# SERVICE LETTER

**No. 578A**

Fuel Line Inspection and Support Clamp Installation (Reference attached Lycoming Service Bulletin No. 335A, dated April 14, 1972).

Service Bulletin No. 335A  
(Supersedes Service Bulletin No. 335)  
Engineering Aspects are  
FAA (DEER) Approved

Fuel Line Support Kit, View Showing Order of Assembly

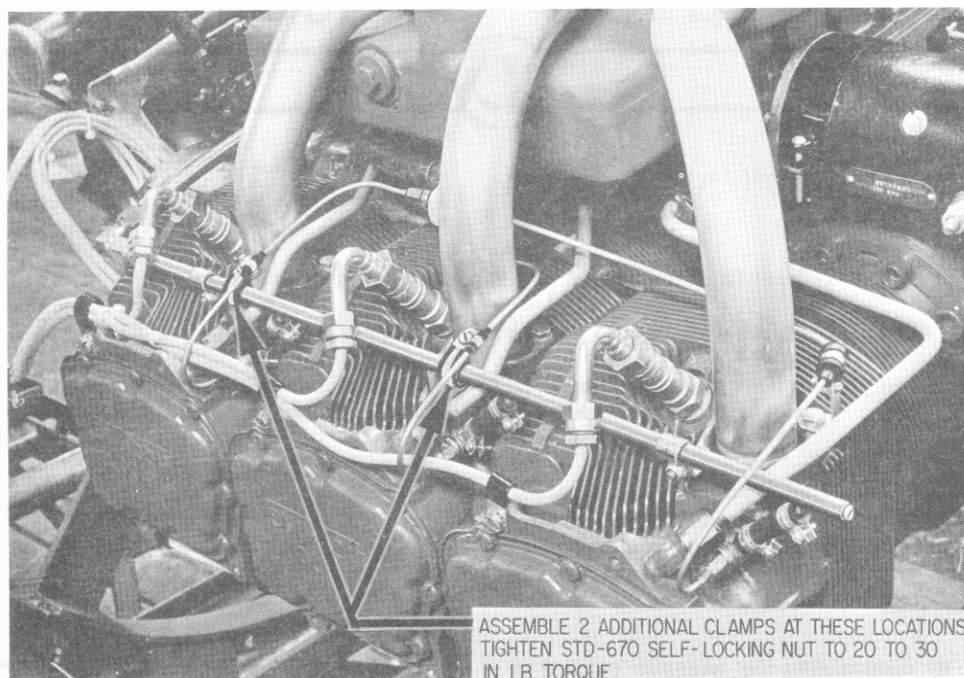
4. Using the parts furnished in the modification kit, proceed to assemble the additional clamps as shown in the accompanying illustration.

If difficulty is experienced when installing clamps on a cylinder fuel injector line due to aircraft baffling, the clamps may be installed in reversed position to provide clearance.

Left, Underside View of Engine Showing Location of Fuel Line Clamps

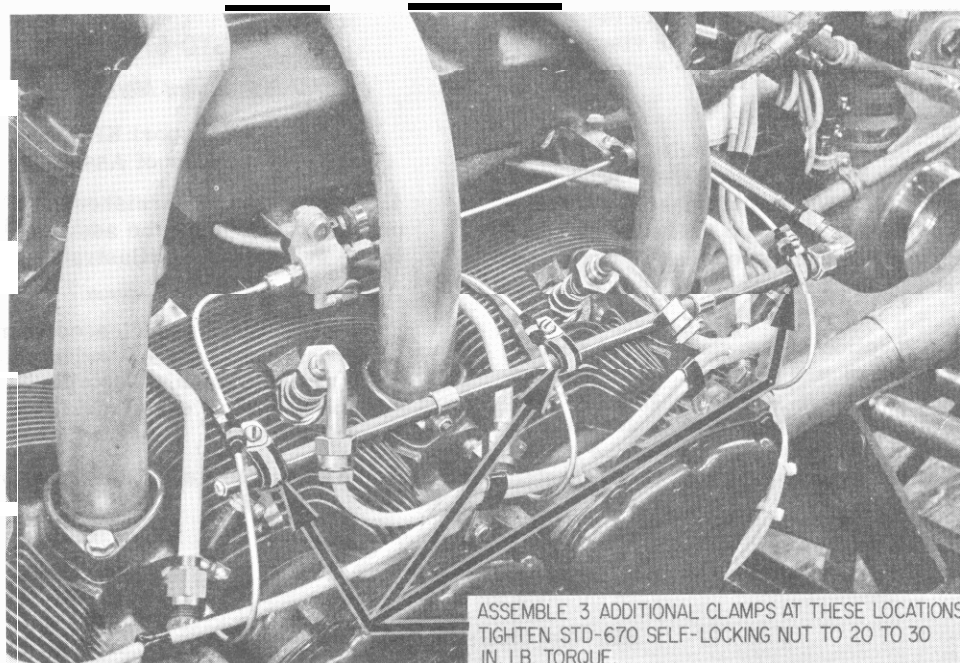
3. Examine the location of the clamps that secure the lines to the engine and compare them with the illustrations shown here. If any clamp **is not** located exactly as shown, correct it before proceeding to the next step. Also, examine the line at the clamp location for chafing. Replace any line that is chafed at the clamp location.

NOTE: Revision "A" to Service Bulletin No. 335 deletes LW-12145; adds MS-21919.DF4 and LW-12598 at same locations, revises step 3 to add inspection for chafing, and adds -1 to Kit No.
